## REVISED RESPONSE TO REQUEST FOR ADDITIONAL INFORMATION

### APR1400 Design Certification

Docket No. 52-046

RAI No.: 61-7984  
SRP Section: 08.03.01 – AC Power Systems (Onsite)  
Application Section: 8.3.1  
Date of RAI Issue: 07/06/2015

< The mobile generators are connected to Class 1E power distribution system train A or B.>

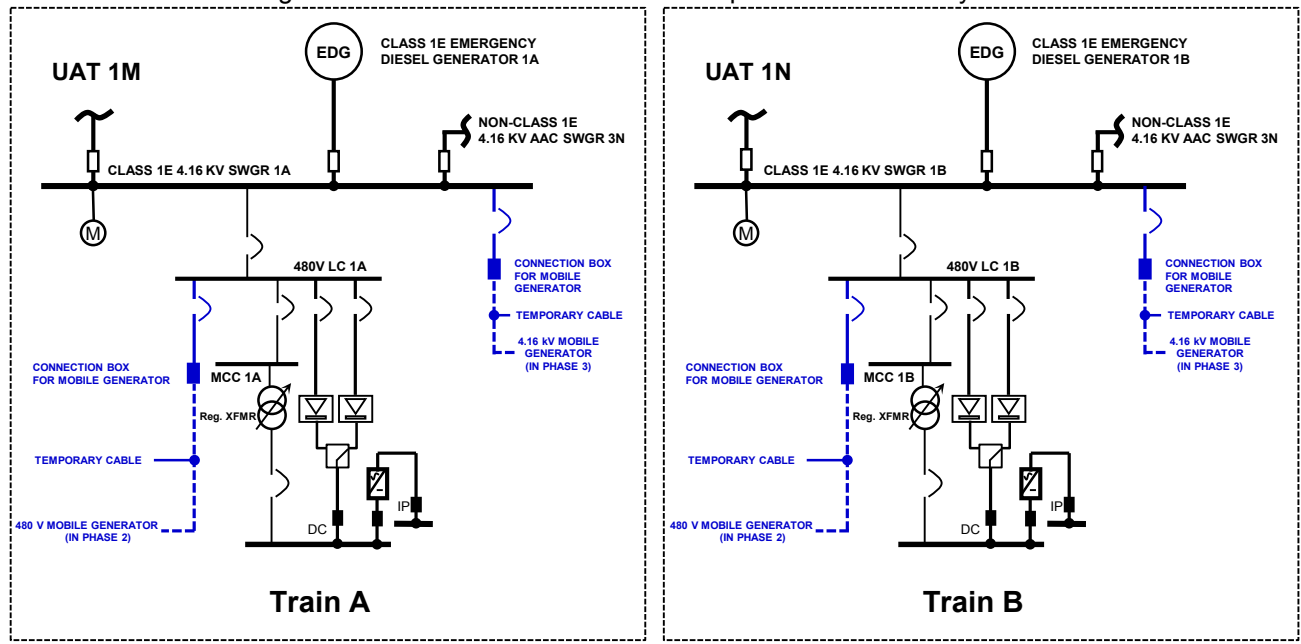
Provide a summary of the design aspects of the mobile generator, including anticipated physical location, connection configuration, the method of transferring the source to safety buses, specification of the equipment, details of support equipment.

Class 1E loads are divided into two redundant load groups (Divisions I and II). Each division has two independent subsystem trains: trains A and C (Division I) and trains B and D (Division II). The mobile generators are connected to the Class 1E power system train A or B at each phase of the mitigation strategies for BDBEEs.

- Phase 2 : 480V mobile GTG connected to the LC bus
- Phase 3 : 4.16 kV mobile generator connected to the SWGR bus

The mobile generators supply power to the Class 1E bus through connection boxes. Power cables between the connection boxes and the incoming circuit breakers of the Class 1E buses are permanent installations. Connections between the mobile generators and the connection boxes are implemented by temporary cabling.

To illustrate the preceding, a simplified single-line diagram is provided below.
